Subject: **THIRD RESPONSE TO PEER REVIEW**
Phase 2 of Tentative Tract 37-46
White Mountain Estates Subdivision
Chalfant Valley, Mono County, California

Reference: Review of Revised Site Geologic Map
Phase 2 of Tentative Tract Map No. 37-46
White Mountain Estates Subdivision
Chalfant Valley, Mono County, California
Prepared by AMEC Earth & Environmental dated June 13, 2006

PROJECT: GEOLOGIC LOG OF TRENCH T-11 PHASE 2 OF WHITE MOUNTAIN ESTATES SUBDIVISION				
HORIZ. SCALE: 1"=5'	VERT. SCALE: 1"=5'	DATE: 8/16/2006		
DRAWING: 3.30559_TRENCHES.DWG	LOGGED BY: HDD/RWS	DRAFTED BY: HDD/RWS		
JOB NO.:	3.30559	TITLE: SHEET 4 OF 5

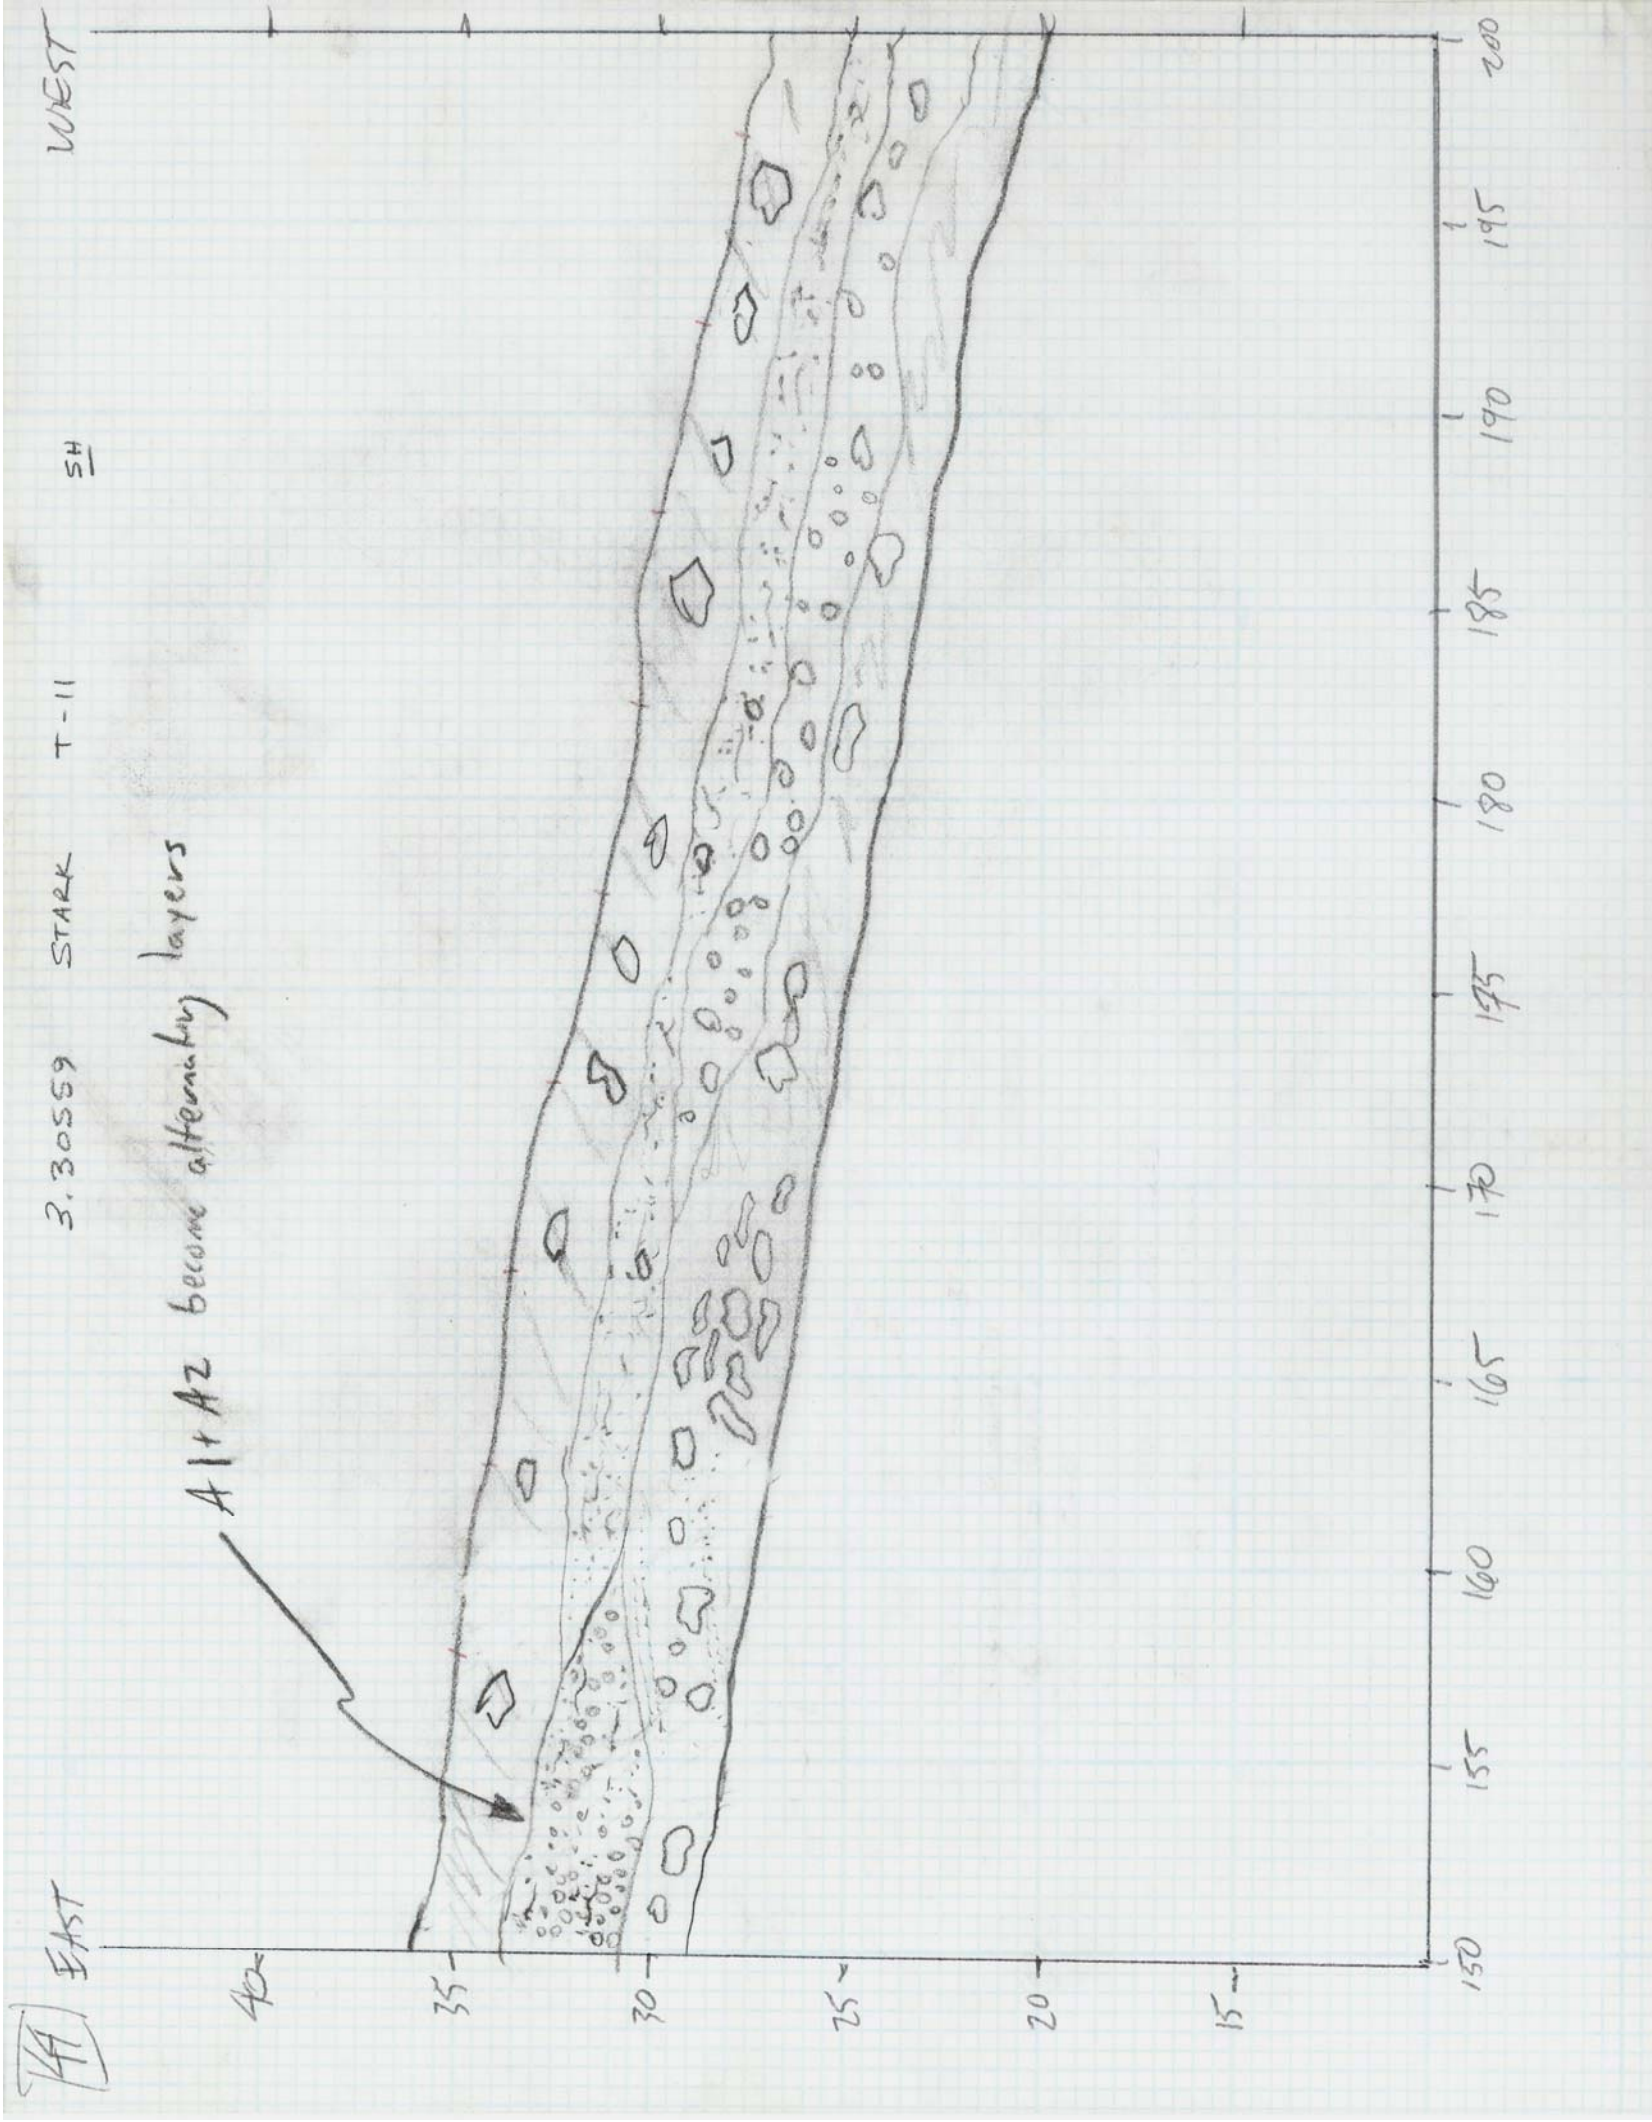
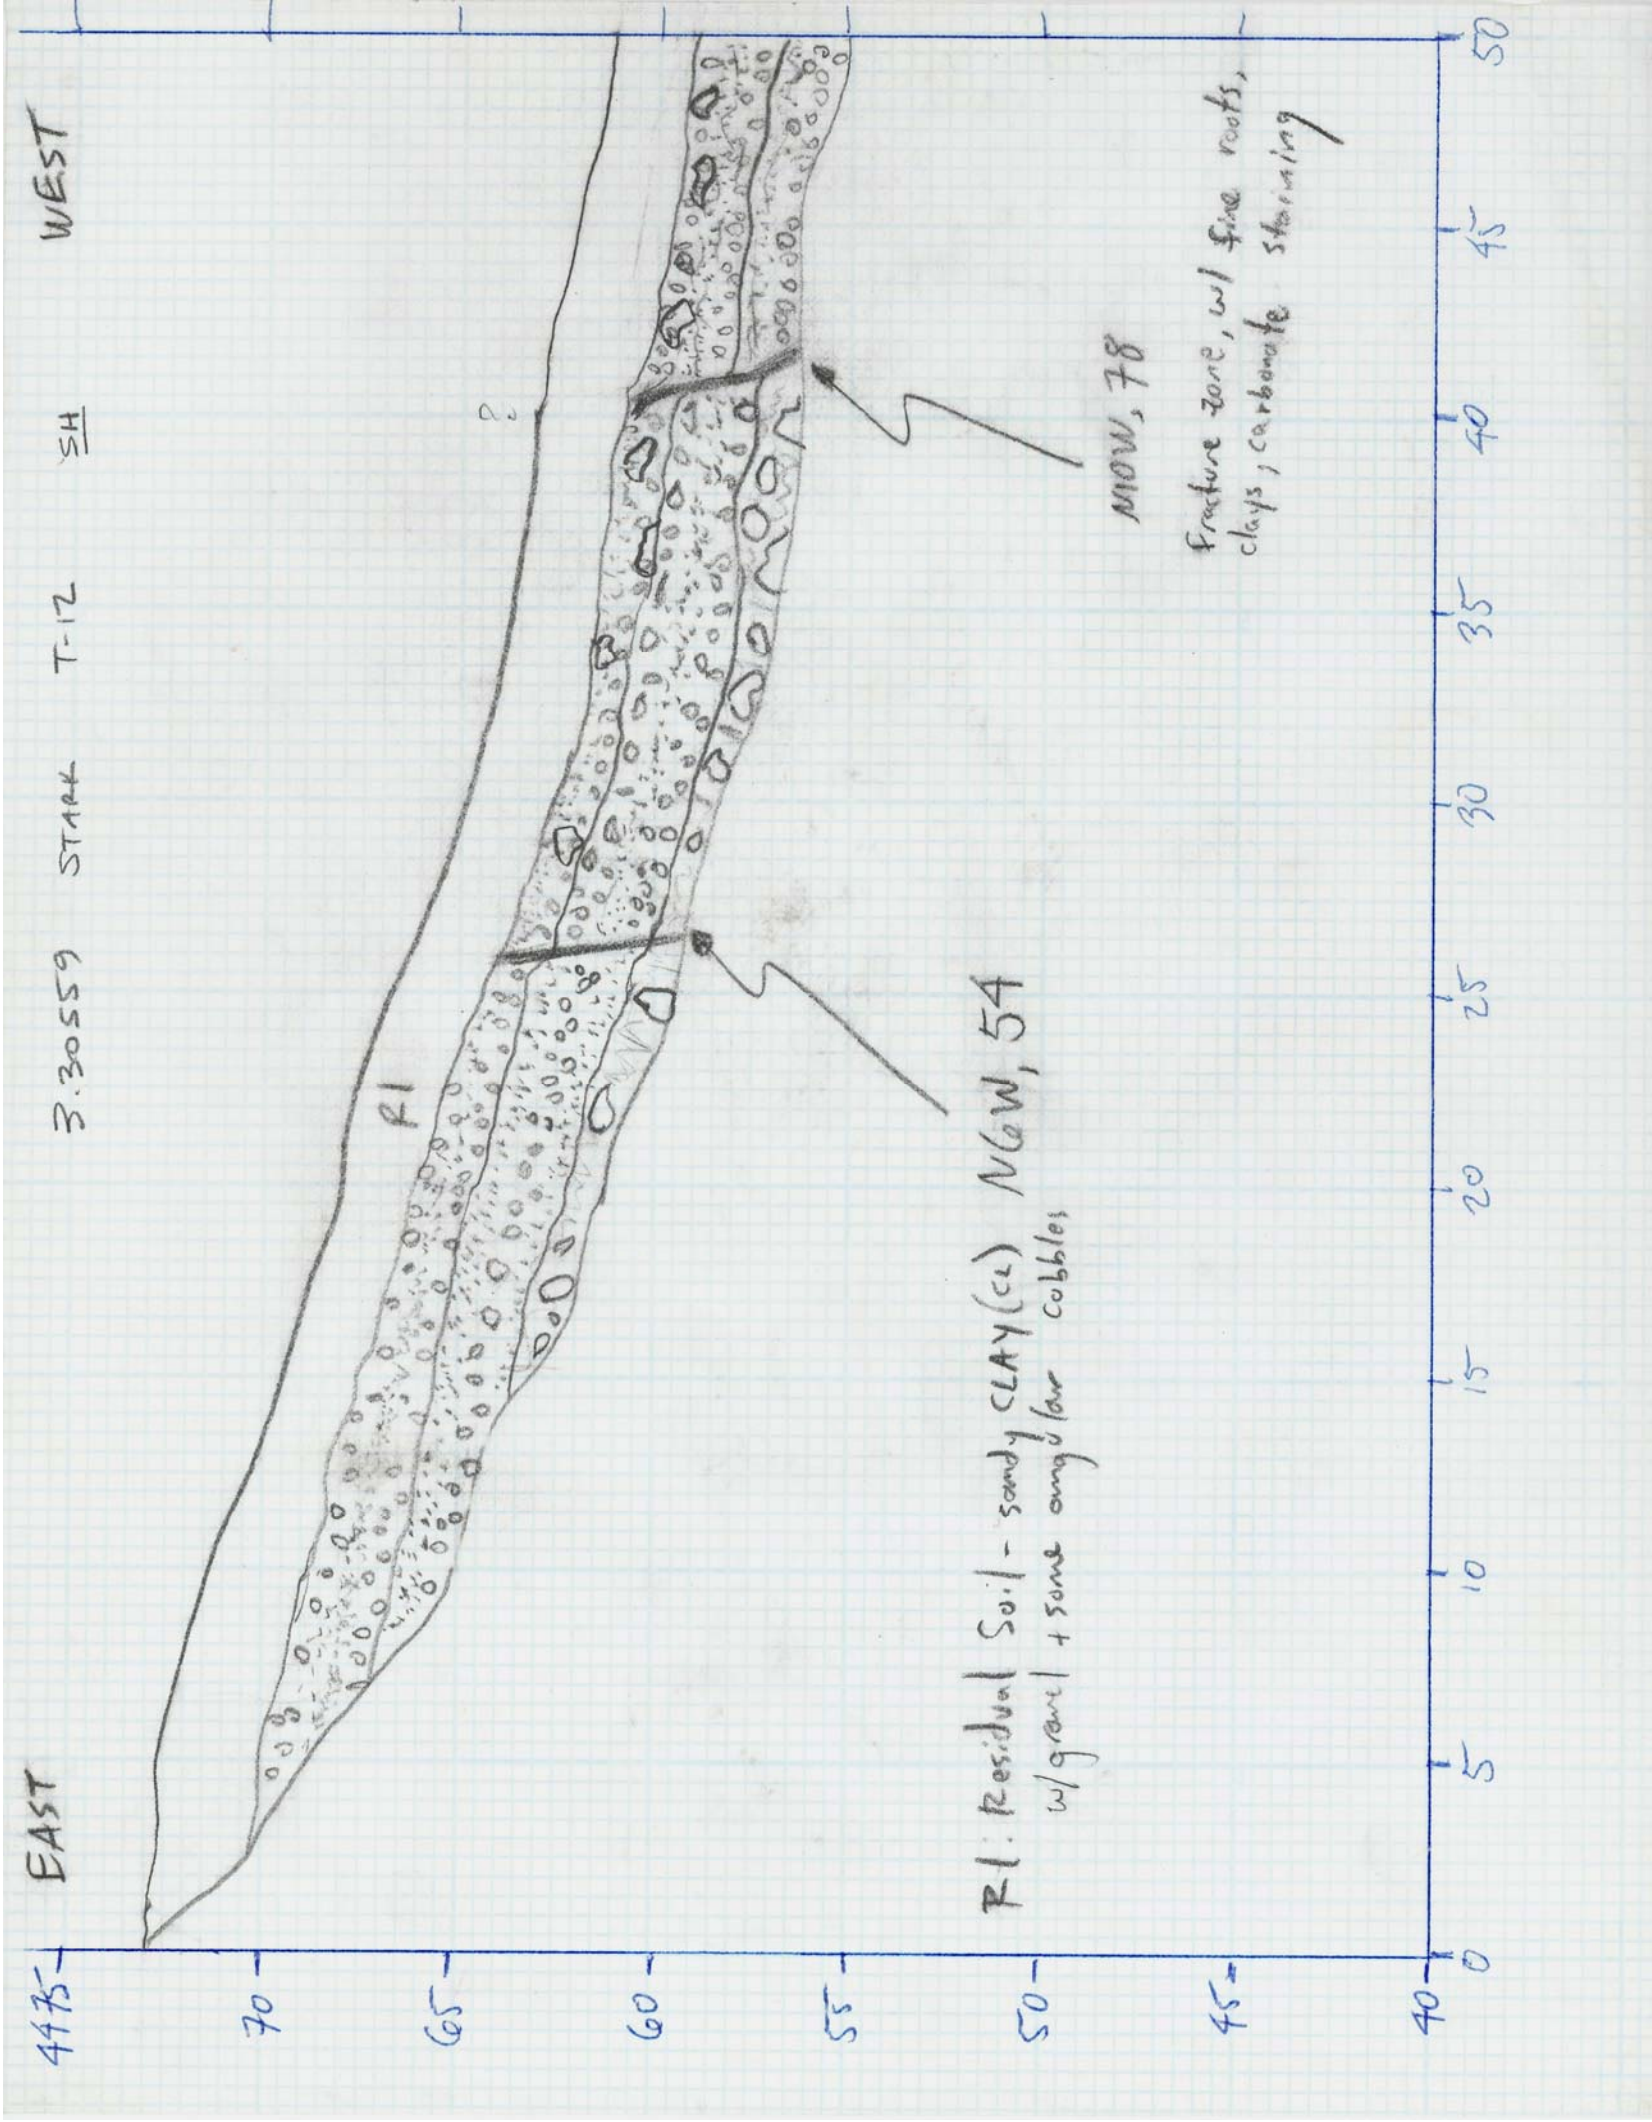
Due to the uncertainty associated with the location or projection of active fault features from the existing exploratory fault trenches it is recommended that Minimum building areas be established for each lot within the existing habitable zones. Building areas that can be established immediately adjacent the existing fault trench excavations are approved with respect to active faulting based on the existing data. Proposed building areas that are more than 50 feet from an existing fault trench will require additional subsurface fault trenching to establish that the building area is free of active faulting. The location of any proposed additional fault trenches, to substantiate the validity of a proposed building area, should be reviewed and approved by the geotechnical consultant for Mono County prior to excavation and logging. The designation of acceptable building areas, verified by the existing fault trench data or new fault data as discussed above, should be accomplished prior to Mono County's approval of the tract.

Response: Two additional fault trenches were proposed and located upon approval via telephone and email from the geotechnical consultant (AMEC) for Mono County. Each trench was located to provide additional data within those habitable areas that had been previously established by rather lengthy projections. Additional Fault Trench T-11 was excavated and logged across the habitable zone that traverses proposed Lot 43, and additional Fault Trench T-12 was excavated and logged across the habitable zone that traverses proposed Lot 41. Each trench exposed faulting OUTSIDE of each habitable

zone as was anticipated from our previous findings. Faulting was NOT observed within either habitable zone on either lot. Therefore, we have revised each habitable zone to reflect these findings, and they are shown on the attached Revised Site Geologic Map. Based on the dimensions of the largest footprint of the manufactured homes that are proposed for the subject site, Minimum Building Areas (MBA) have also been established for each lot within each revised habitable zone. It should be noted that each MBA location is provided to demonstrate fit and buildability within the habitable zone only; they are not intended to restrict structures to that location or dimension. The west side of the habitable zone across Lots 40 and 42 has been revised such it is now setback fifty feet from the nearest mapped fault to the west, and as a result the MBA on Lot 42 has been repositioned inside the habitable zone such that there is still adequate room for a habitable structure. Additionally, the habitable zone has been removed from proposed Lot B Common Area for Phase 1 of Tentative Tract 37-46 since the proposed water storage tank and propane tanks are not habitable structures; however, their proposed locations have been plotted such that they are as far away as possible from the nearest mapped faulting on this lot in order to minimize the potential for disruption or damage to the tanks from future ground surface rupture-causing events.
